SAFETY EVALUATION REPORT

SOURCE MATERIAL LICENSE

TETON EXPLORATION DRILLING CO., INC.

LEUENBERGER SITE, CONVERSE COUNTY, WYOMING

Figure 3-6

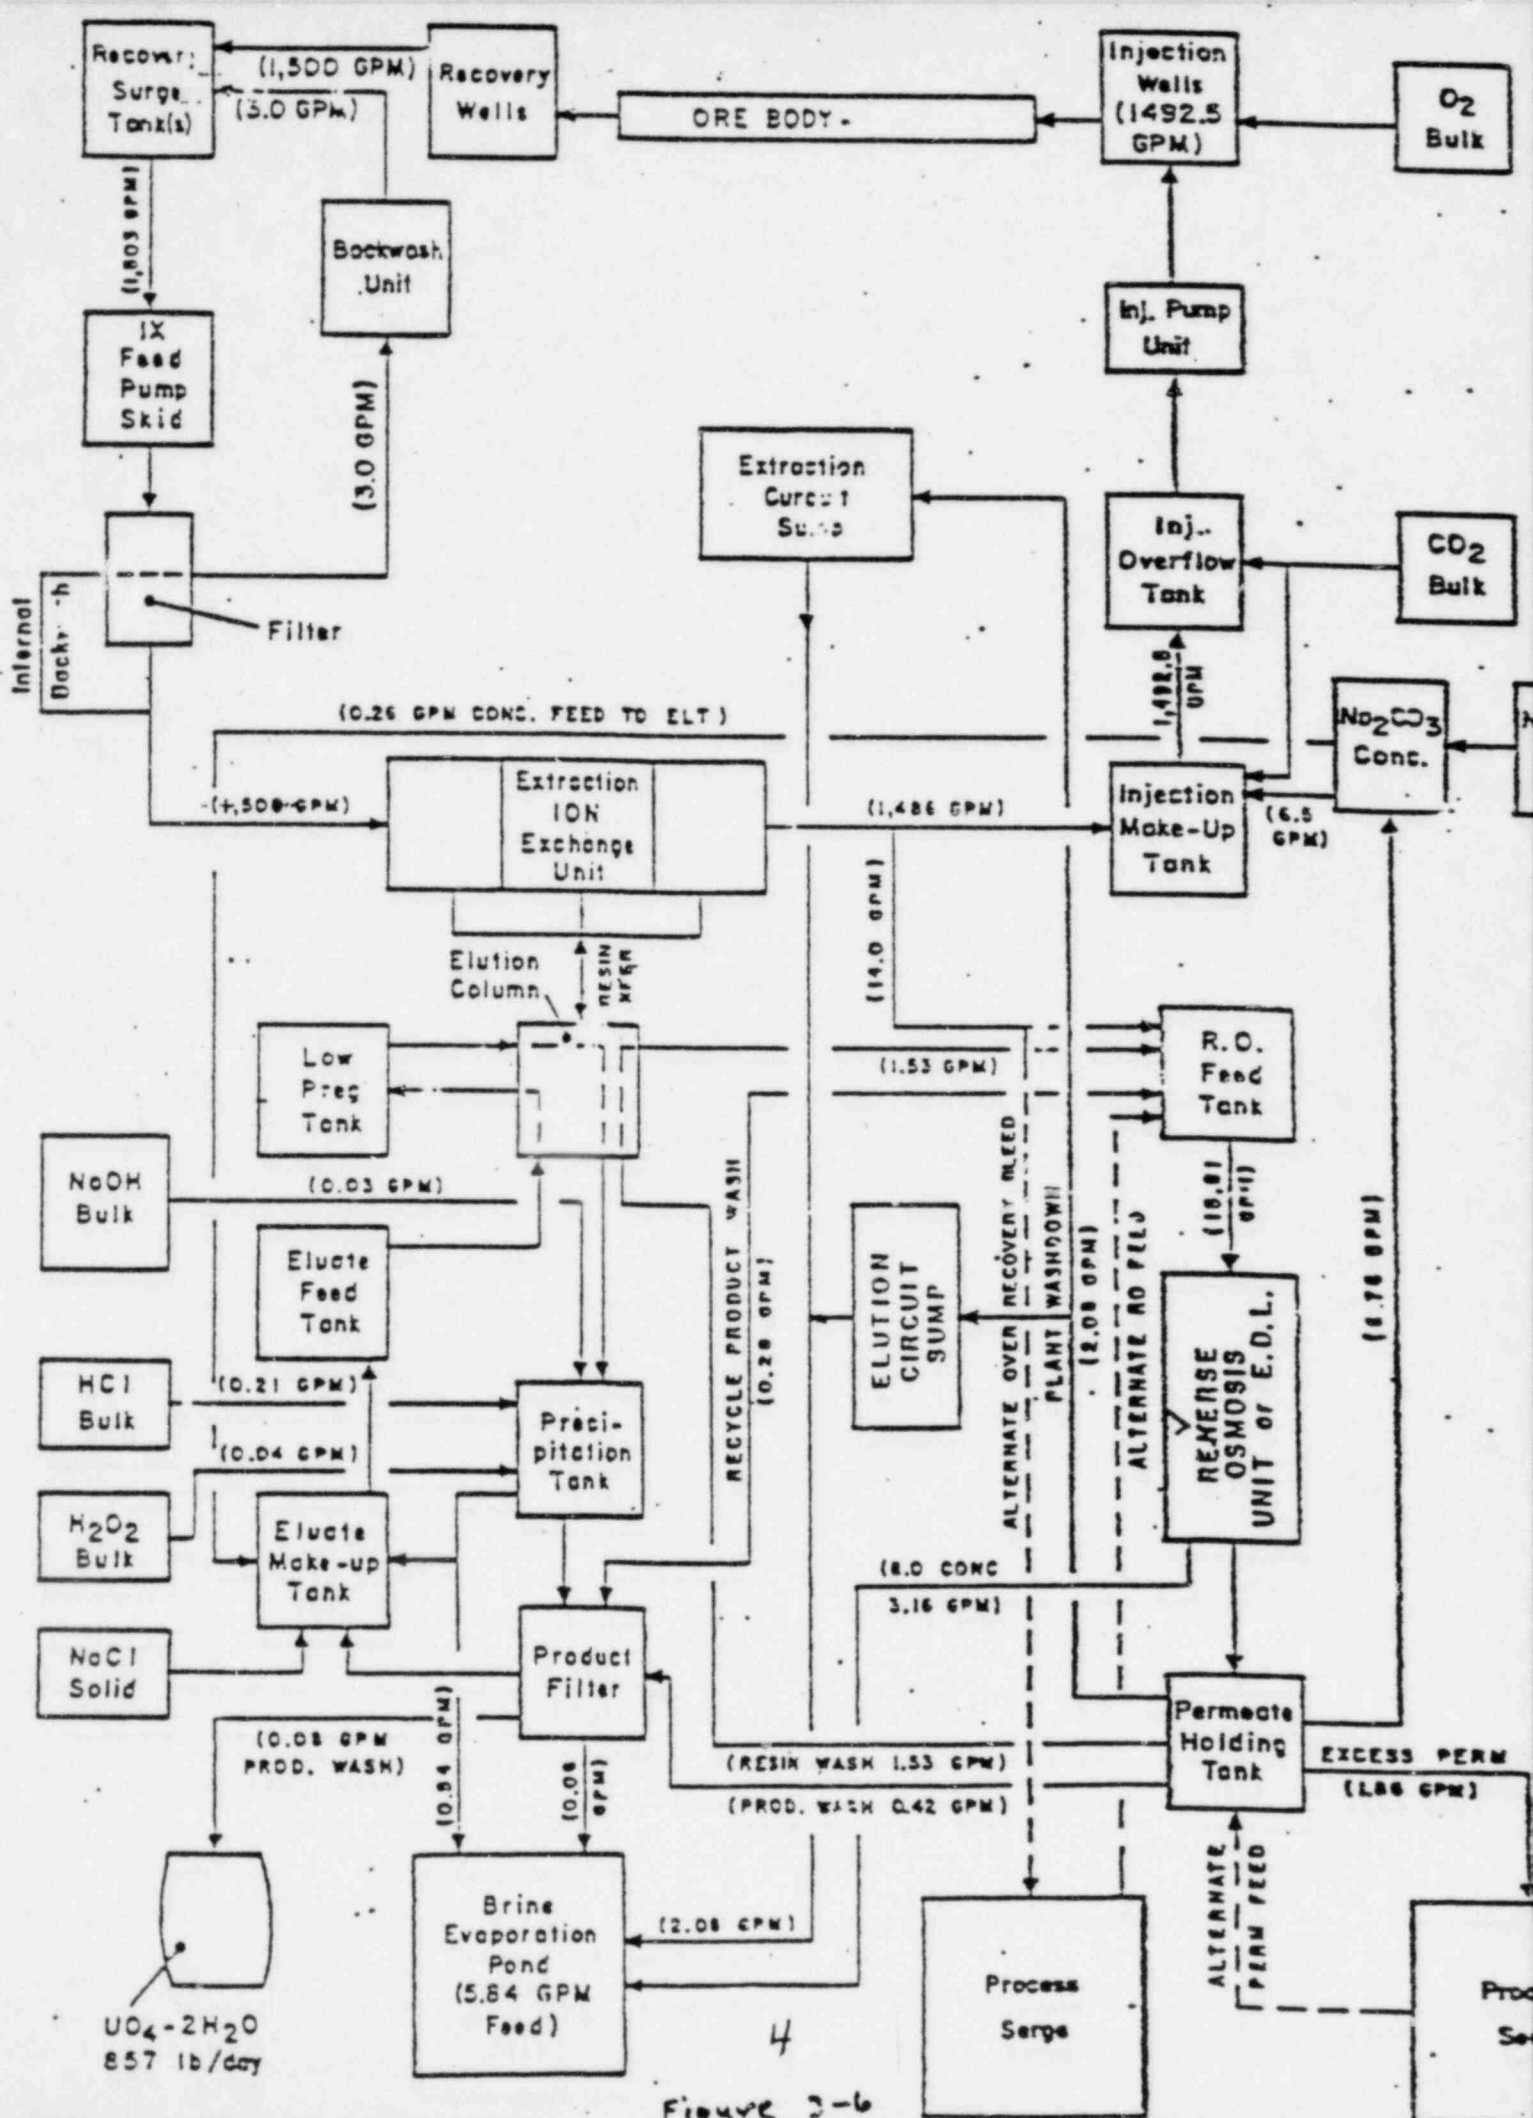
The recovery plant will have a design process flow rate of 2,000 gallons per minute when mining, process operations, and ground water restoration are operating concurrently. The recovered leach solution will be surged in tanks located in the process plant building and from there will be pumped through ion-exchange (IX) vessels where uranyl bicarbonate-uranyl tricarbonate will be adsorbed into a strong base anion exchange resin. The uranium product will be eluted from the resin by a chloride or sulfate ion solution and the yellowcake will finally be precipitated with hydrogen peroxide. The process flow sheet and major process plant equipment are shown on the enclosed Figure 3-6 from the application.

18. Any changes in the process circuit, illustrated and described in Figure 3-6 of the license application dated October 10, 1980, shall require the approval of the RPO and shall be submitted to the U.S. Nuclear Regulatory Commission, Uranium Recovery Licensing Branch for prior approval in the form of a license amendment.
19. The licensee shall use external personnel dosimeters, either TLD or film type dosimeters, that are designed to measure exposure to penetrating radiation (e.g., gamma radiation and beta particles with a range greater than 7 cm^2). The dosimeters shall be exchanged and read monthly.

FIGURE 5-1 TETON CORPORATE ORGANIZATION

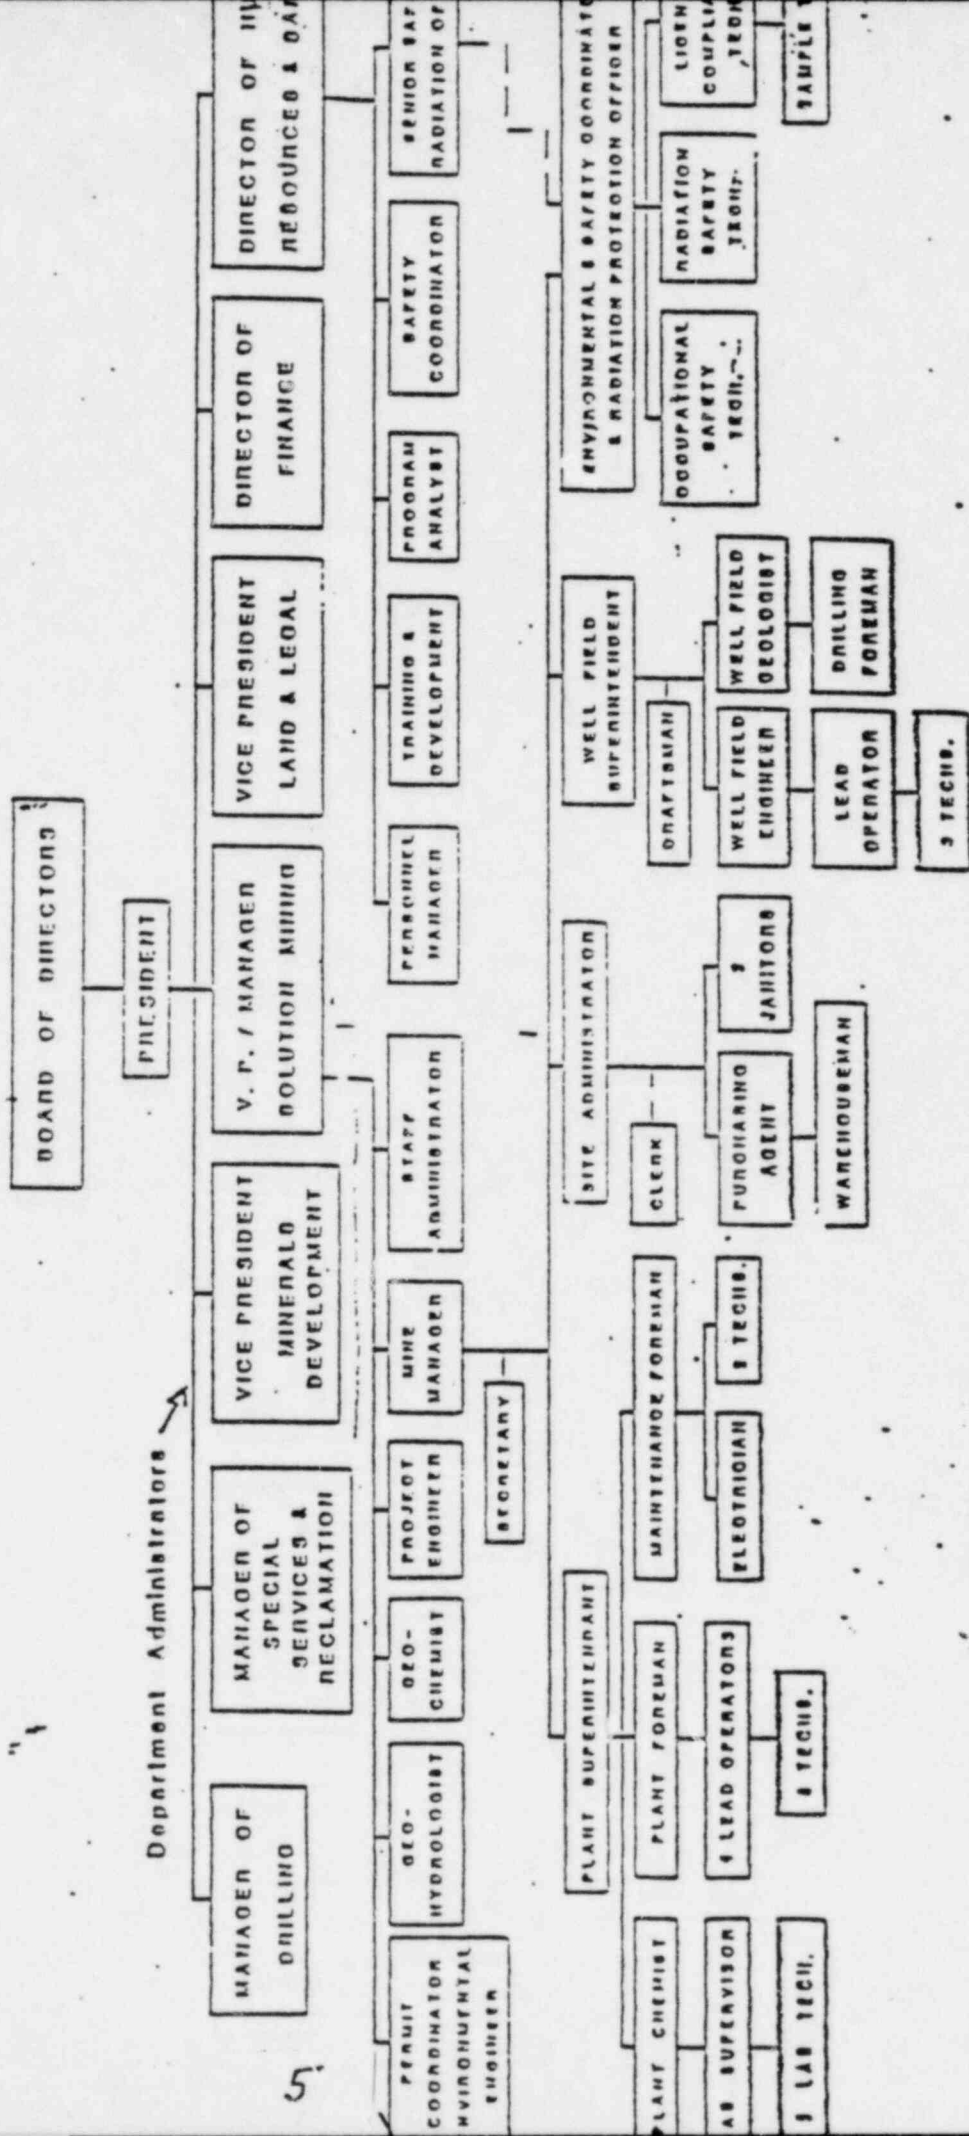
The applicant has enclosed in Section 5.1 of his application a description of his organization (See enclosed Figure 5-1). The mine manager at the Leuenberger Project, the highest corporate official onsite, is responsible for the conduct of daily activities, including the conduct of the radiation safety and environmental monitoring programs. The mine manager obtains technical support from the Solution Mining Department at the Teton Casper office. The Environmental and Safety Coordinator/Radiation Protection Officer (RPO) is charged with supervising the safety and environmental activities. The RPO reports directly to the Mine Manager.

The staff concludes that the organization of the radiation safety function as proposed by TEDI is acceptable.

FIGURE 5-2 PROCESS PLAN: RADIOLOGICAL MONITORING STATIONS

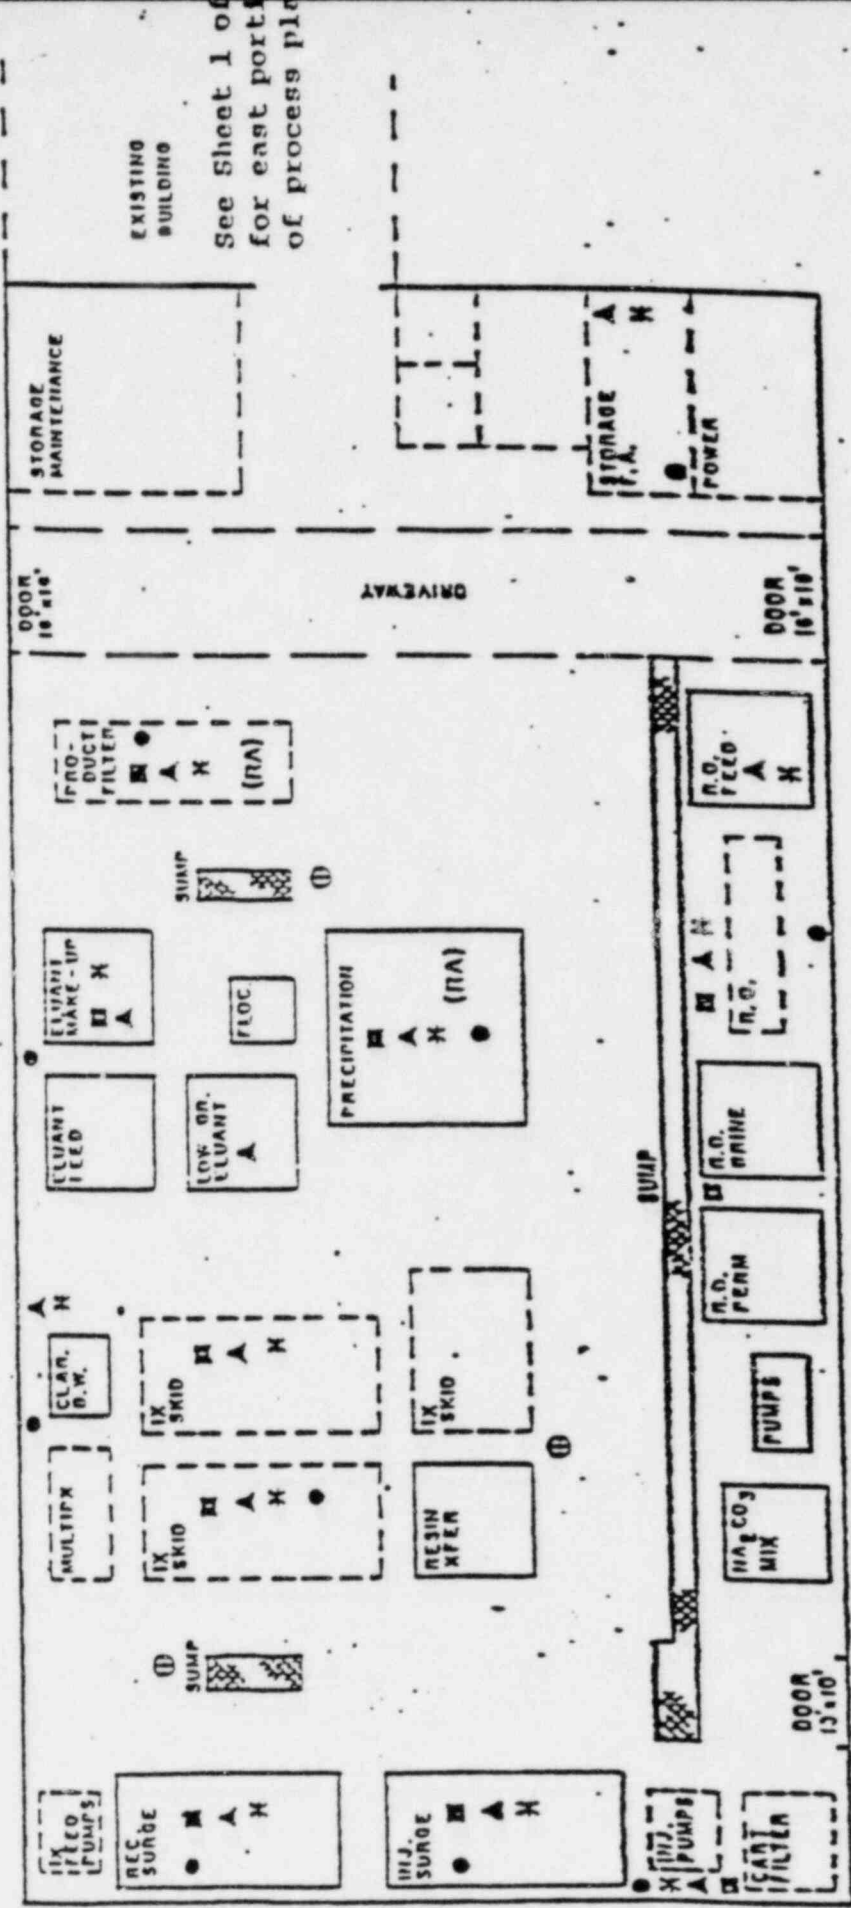
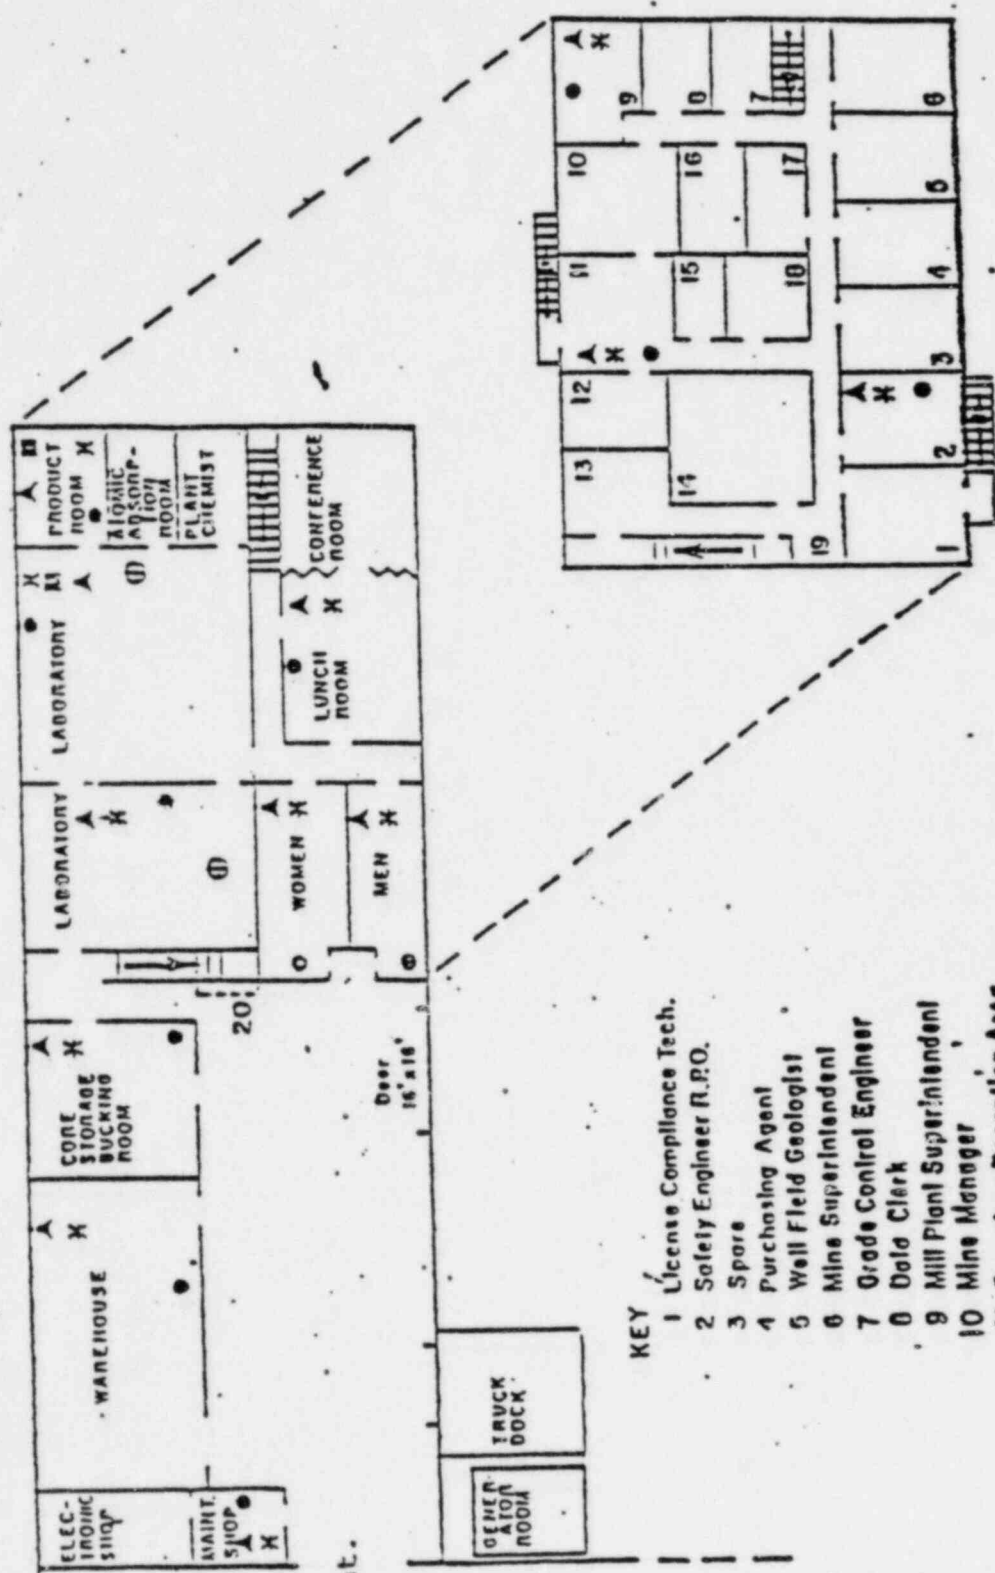
The applicant has proposed locations for radon sampling in Figure 5.2 of the application, enclosed. There will be 10 radon sampling locations as listed below:

The applicant's proposed program serves two purposes: i.e., sample the locations having the highest potential for radon emission (the surge tanks) and provide a good coverage of the entire building in the event of a slow radon leak causing accumulation of this gas in some portion of the building that we cannot predict at this time. Radon sampling will be performed monthly; and if monthly samples exceed 25 percent of the applicable value in Appendix B of 10 CFR 20, the sampling frequency at these locations will be increased to weekly until four consecutive samples are below 25% of the applicable limit. Then the frequency may be decreased to monthly.

The staff has determined that Teton's air sampling program is satisfactory. Teton's selection of air sampling survey locations provides a good coverage of the entire building as well as including those locations having the greatest potential for significant concentrations of airborne radioactivity. The licensee's weekly surface contamination program described in Section 6.0 will be capable of detecting contamination in certain locations in the building after the licensee's uranium air sampling program becomes restricted to the

The application has proposed that a survey be made quarterly within the restricted area to determine gamma radiation exposure rates at 20 representative locations shown in Figure 5-2 of the application. Measurements will be in mR/hr and will be made with an Eberline Model FRS-1 ratemeter equipped with an HP-270 probe or equivalent equipment. The staff has determined that this program is acceptable.

uranium packaging area. Also, the staff has added a license condition requiring Teton to conduct a daily inspection program capable of visually detecting yellowcake contamination that may have been spread from the processing areas.
